MOFFETT-WOLF SUBDIVISION

APPLICATION NUMBER 14 DATE February 3, 2005
APPLICANT Moffett-Wolf Subdivision
REQUEST Subdivision

MOFFETT-WOLF SUBDIVISION

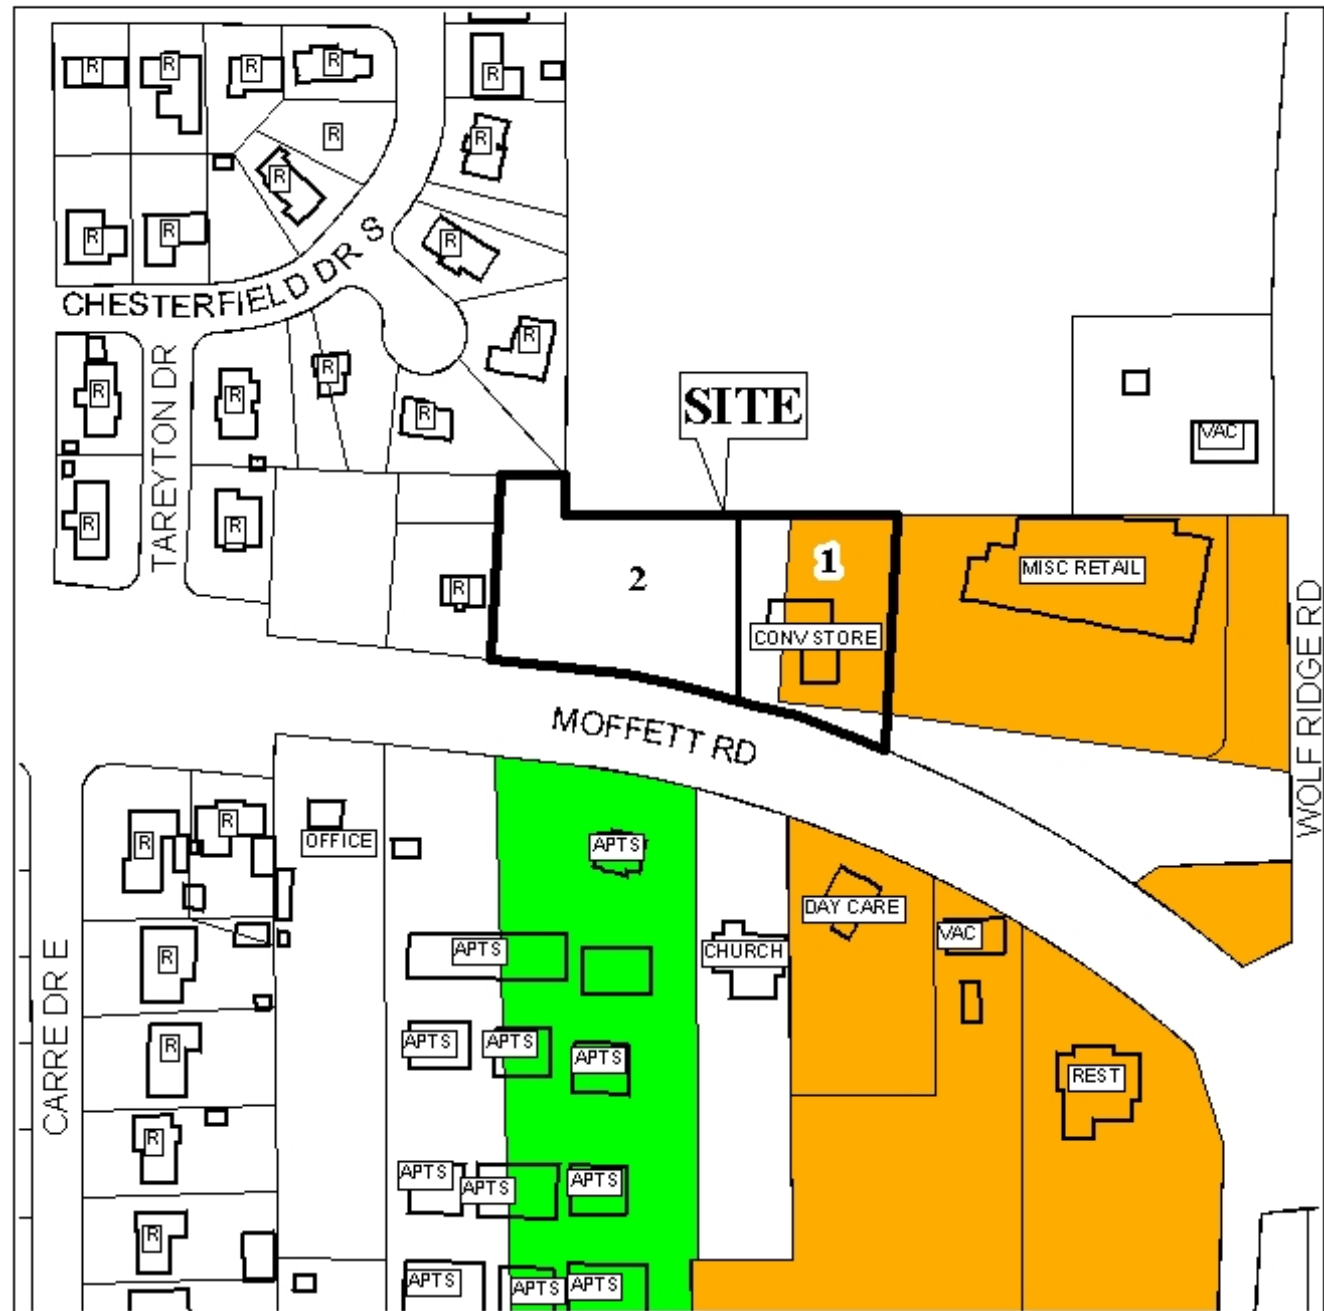
As the site fronts a major street, access management is a concern. The site currently has three curb cuts – two serving the existing commercial use on the proposed Lot 1, and one serving an apparent single-family structure located on the western portion of the proposed Lot 2. No additional curb cuts should be allowed for the proposed Lot 1, and Lot 2 should be permitted only one curb cut, with the location, size, and design to be approved by Traffic Engineering.

The 25-foot minimum building setback line is not shown, but would be required on the Final Plat.

The existing parcel is split-zoned, with the majority of the site zoned R-1, and a majority of proposed Lot 1 zoned B-2. Prior to the recording of the Final Plat, the proposed Lot 1 should be rezoned to fully encompass B-2 zoning, which permits the existing convenience store with gas pumps.

The plat is recommended for Tentative Approval subject to the following conditions: 1) the depiction of the 25-foot building setback line on the Final Plat; 2) rezoning of the proposed Lot 1 to a single zoning classification prior to the recording of the Final Plat; and 3) placement of a note on the Final Plat stating that no additional curb cuts are allowed for the proposed Lot 1, and Lot 2 is permitted only one curb cut, with the location, size and design to be approved by Traffic Engineering.
